Access Compliance Report Public Rights-of-Way (Curb Ramps)

Intersection ID: 53018 Main Street: STEEL HOUSE BV **Cross Street: SPENCER ST** Location: NE **Severity Score:** ADA ID: 7001159DF81D Ramp Type: BlendTrans1 Initial Pass/Fail: Pass **Overall Compliance: No** 10

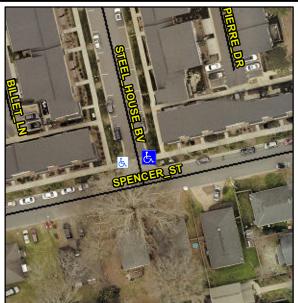
STEEL HOUSE BV Street 1 Name StopSign Stop Condition-Street 1 Street 2 Name N/A Stop Condition-Street 2 N/A Possible Solutions: **Remove & Replace Curb Ramp With Two New Directional Ramps or** Equivalent. Surveyor Notes: **COLLECTED WITH ULIP** PROW/ADA: R304.5.3, R305
